Certificate of Appropriateness

Property 1710 E. PRYOR AV. **Pryor Avenue Iron Well, an individually-designated site**
Description of work Repair the missing and damaged sections of the well head using mortar determined by lab analysis. Install epoxy-coated re-bars where needed. Install clear sealer over restored well head with product that is approved by City of Milwaukee Water Works.

Date issued 9/27/2013 PTS ID 90300 COA, repair well

Pryor Avenue Well

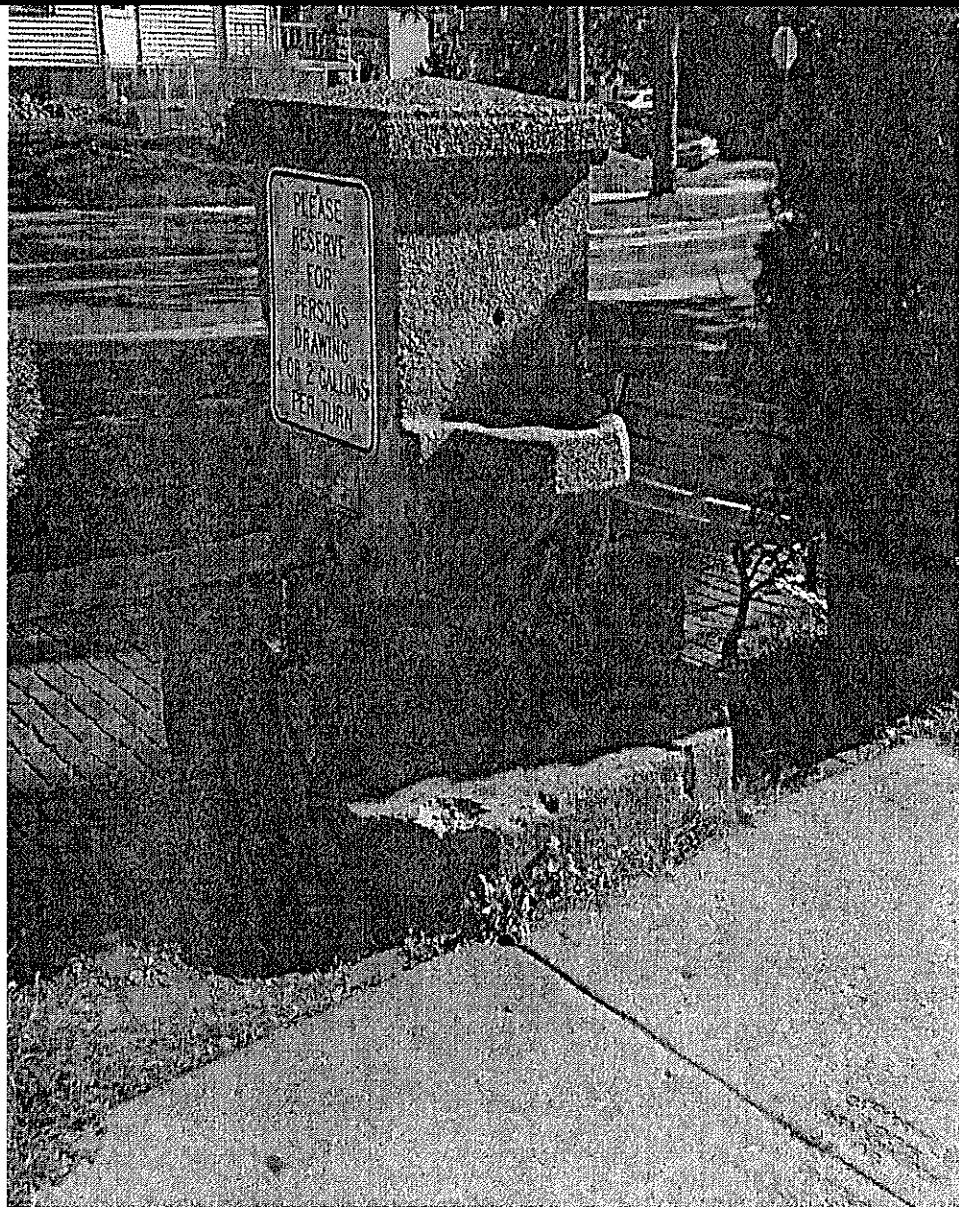
Removal or relocation of the sign off of the well head is encouraged, but not required by HPC staff. Milwaukee Water Works approval would also be necessary

Damaged and missing stone to be patched with new mortar to match the original in terms of color, texture, finish and hardness. Only loose areas should be removed. Material that is sound should remain untouched.

Work at this point is limited to the well head itself. New landscaping around the well will require a separate COA.
